Re: PD Plan & Preliminary Plat, Centerstate East Subdivision (Minor Amendment)

By means of this letter I am approving your request for a minor amendment to the PD development plan known as the, "PD Plan & Preliminary Plat, Centerstate East Subdivision", bearing your seal dated October 17, 2025.

MINOR REVISION #1
CENTERSTATE EAST SUBDIVISION
COLUMBIA, BOONE COUNTY, MISSOURI

PD PLAN & PRELIMINARY PLAN

C1.01

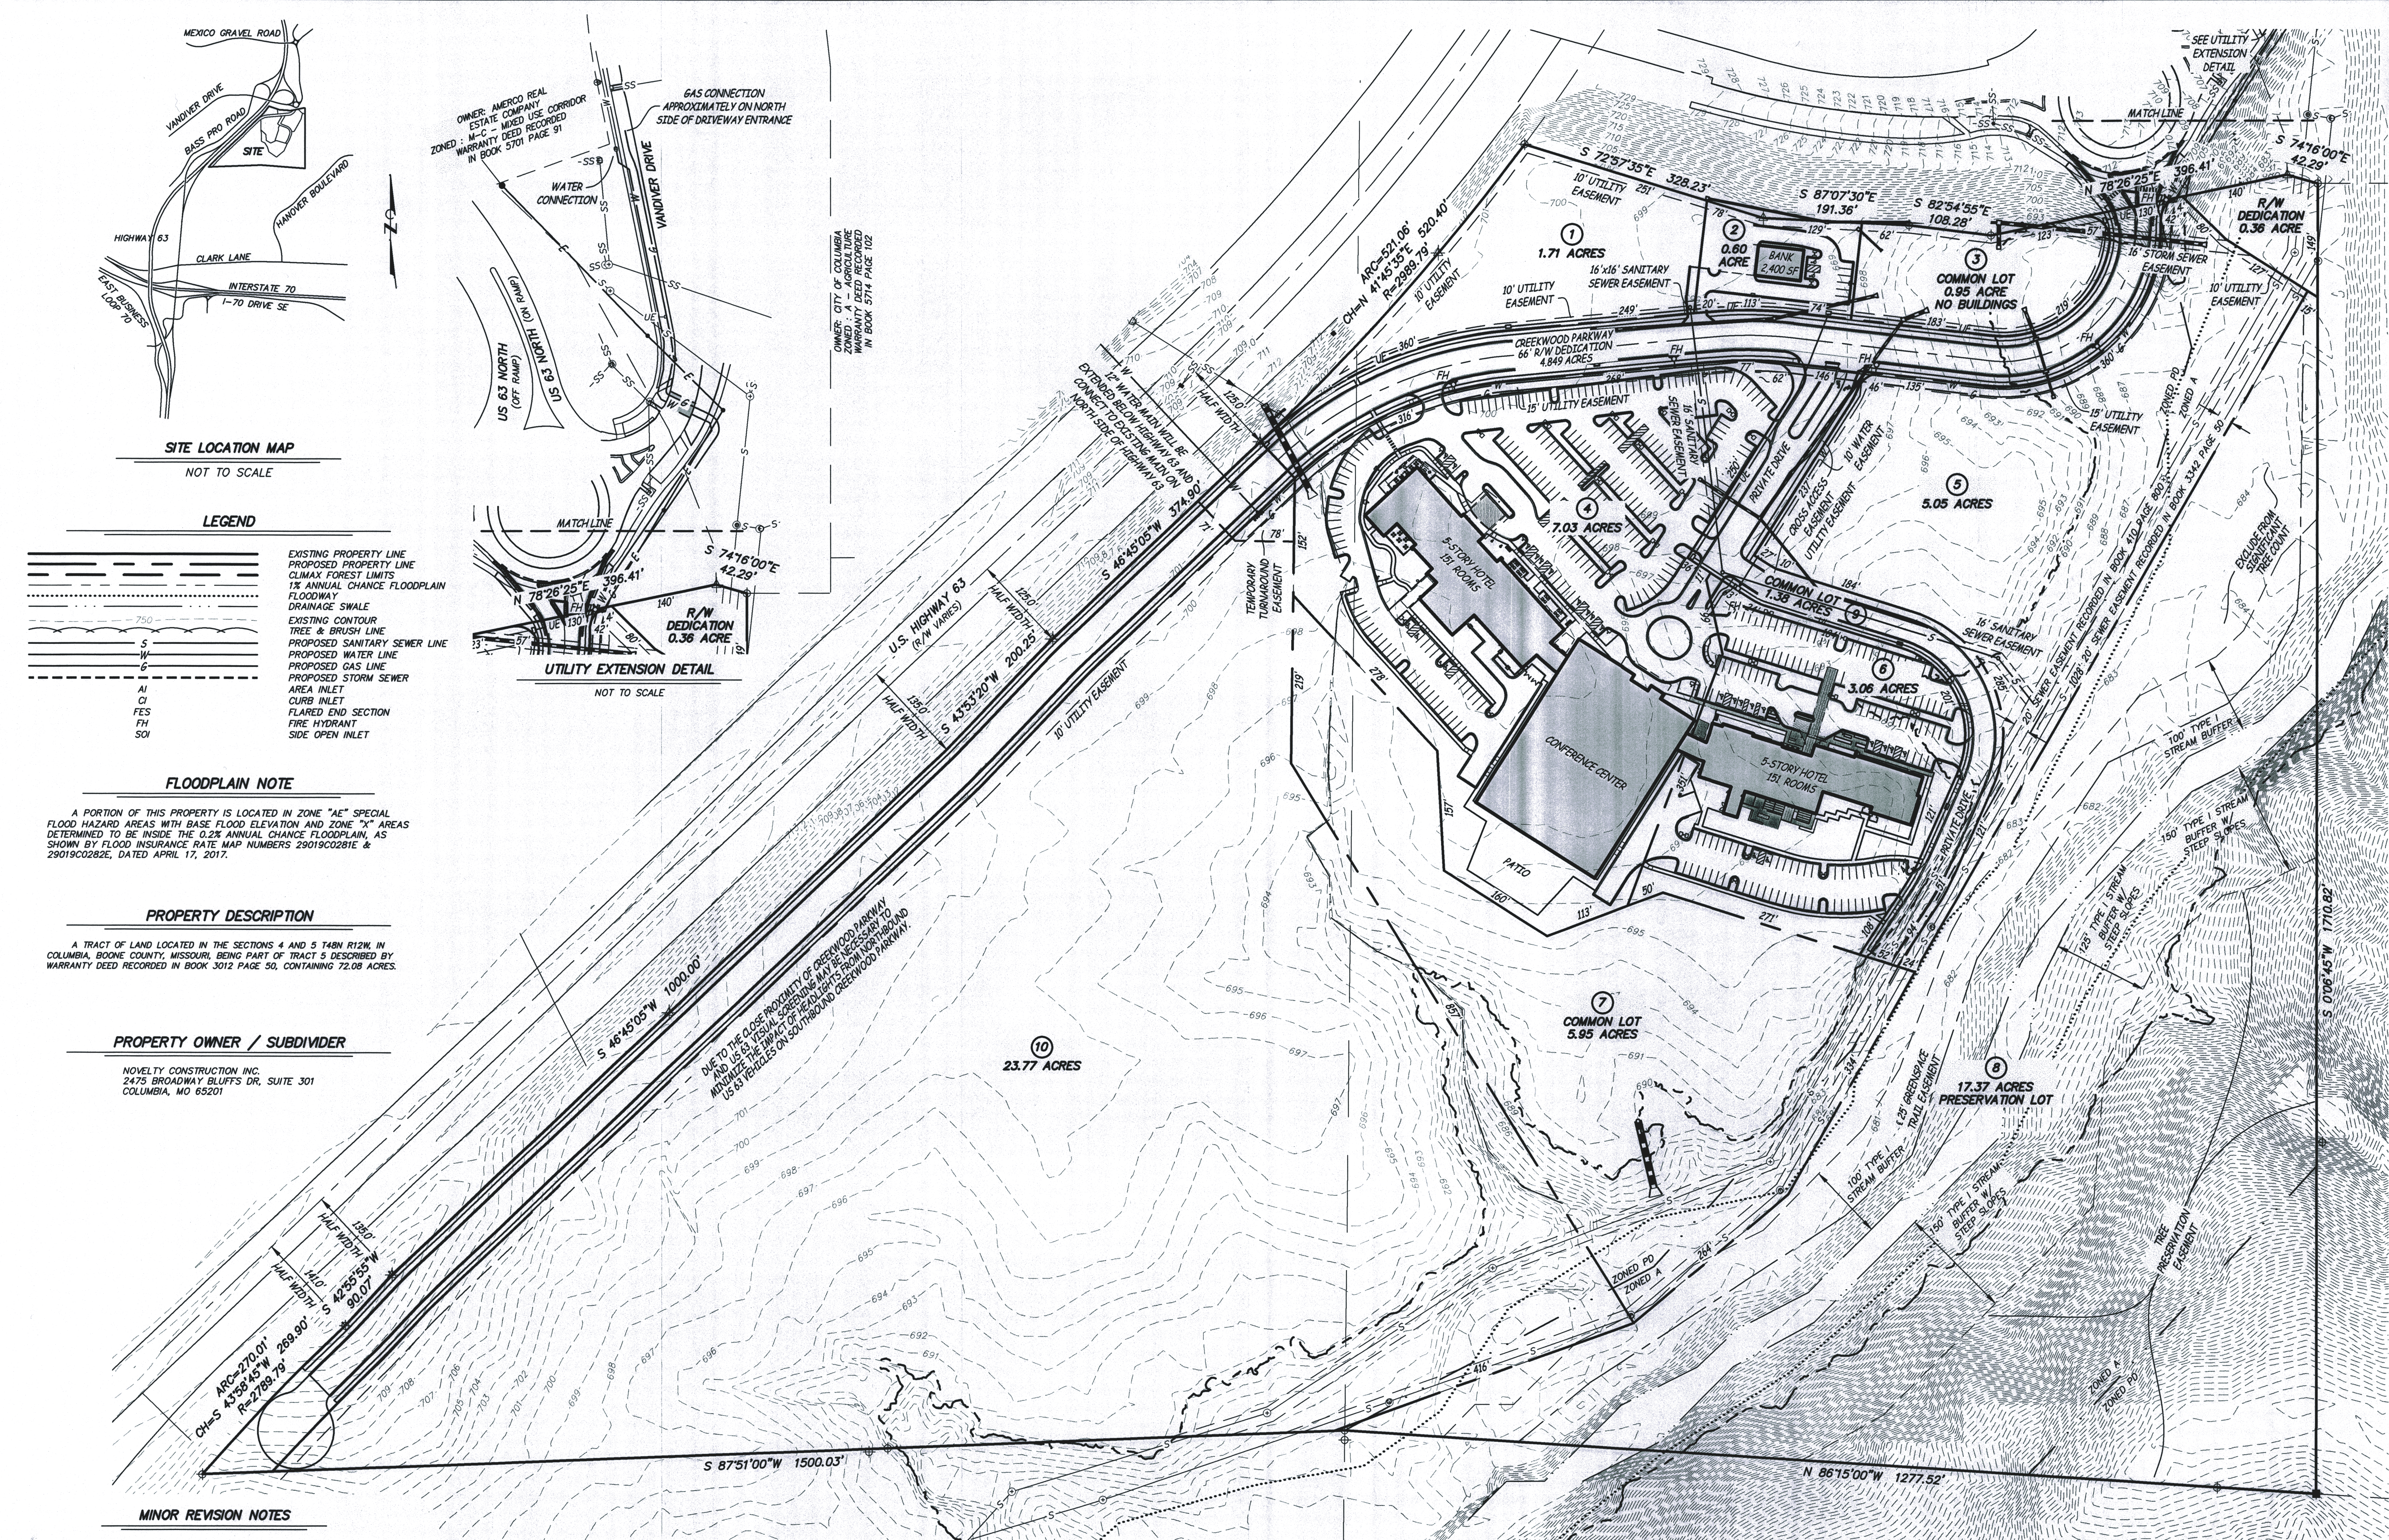
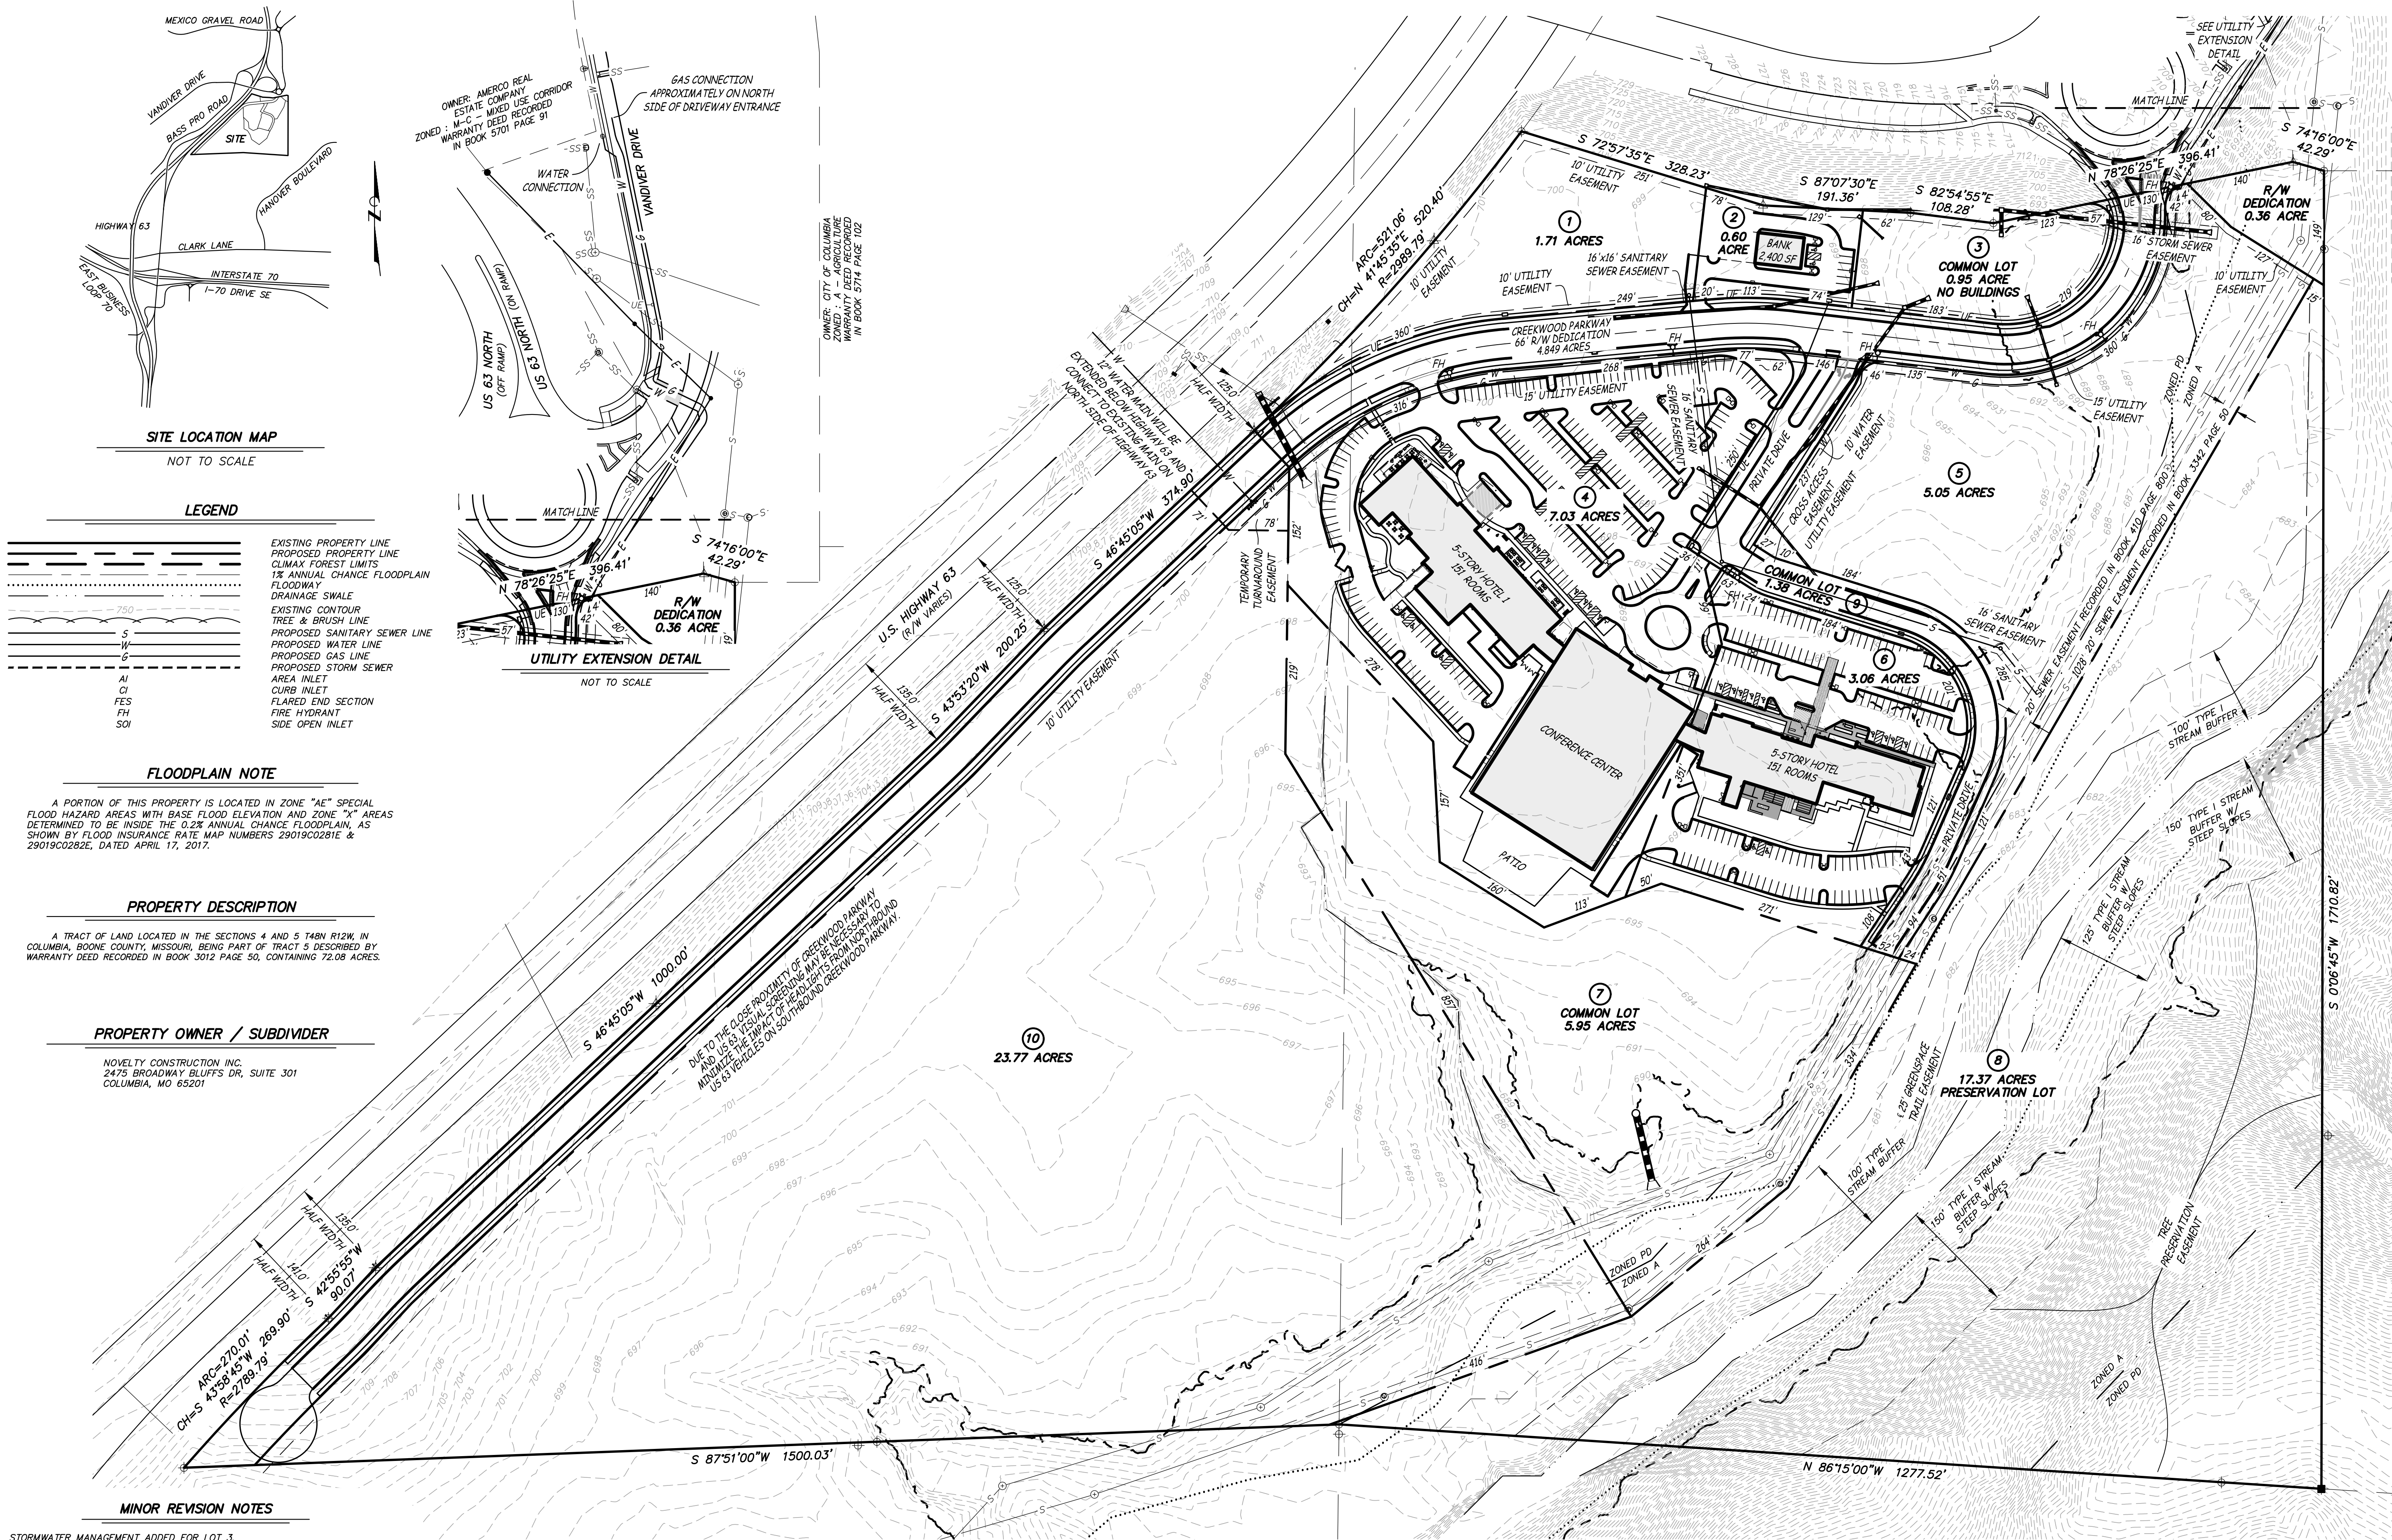
MINOR REVISION NOTES

1. STORMWATER MANAGEMENT ADDED FOR LOT 3.
2. EAST BOUNDARY OF LOT 5, 6, 7, AND 10 MOVED TO MATCH EAST EDGE OF EXISTING SANITARY SEWER EASEMENTS. SEWER EASEMENTS ARE NOW OUTSIDE PRESERVATION LOT.
3. REVISED CREEKWOOD PARKWAY ALIGNMENT FOR DESIGN SPEED.
4. UTILITY LINES & EASEMENTS HAVE BEEN UPDATED TO MAINTAIN 10 FT SEPARATION FROM WATER LINES AND PREVENT WATER LINES FROM RUNNING PARALLEL UNDER PAVEMENT.
5. SANITARY SEWER LOCATION HAS BEEN UPDATED TO SERVE LOTS 1 AND 2.
6. DEVELOPMENT ON LOT 5 AND 6 ROTATED TO ELIMINATE POTENTIAL IMPACT TO WETLANDS ALONG HINKSON CREEK.
7. ADDITIONAL LANDSCAPE ISLANDS ADDED WITHIN LOT 5 AND 6 PARKING LOTS.
8. TREE PLAN UPDATED TO MATCH INFRASTRUCTURE PLAN WITH ADDITIONAL SURVEYED TREES.
9. CORRECTED FLOODPLAIN LIMITS.
10. WEST LINE OF LOT 7 SIMPLIFIED.
11. LOT LINES AND AREA REVISED TO ACCOMMODATE THESE REVISIONS.
